July 5, 2011

RE: CUYAHOGA COUNTY
CITY OF ROCKY RIVER
JOE'S DELI
NPDES PERMIT NO. OHC000003
OHIO EPA PERMIT NO. 3GC05396*AG
CONSTRUCTION STORM WATER

Figure 4: No sediment controls in place except a collapsed silt fence.

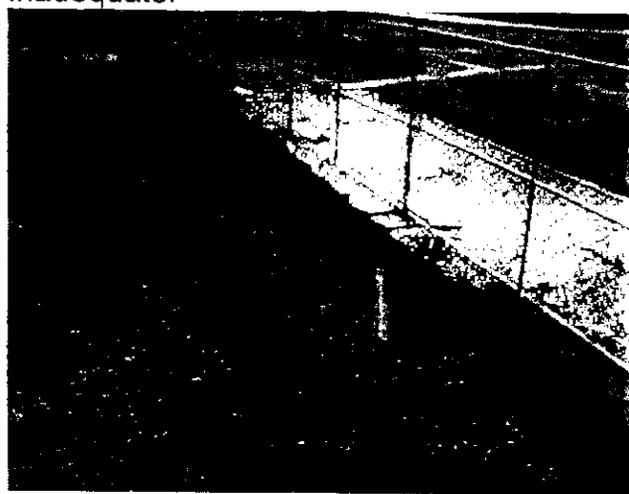
- The silt fence near the entrance of the construction site has fallen over. Please repair or replace silt fence as necessary with the specifications detailed in the Storm Water Pollution Prevention Plan (SWP3) (See Figure 1).
- The construction entrance is inadequate, resulting in offsite tracking of sediment. Please refer to the **Ohio Rainwater and Land Development Manual** (attached) and reconstruct the entrance accordingly (See Figure 2).
- There are no sediment control measures on site near the Hilliard Blvd. intersection. The SWP3 details a silt fence along the perimeter of the site near the intersection but none was present. Please be sure to install silt fence with the specifications detailed in the SWP3 (See Figures 3&4).
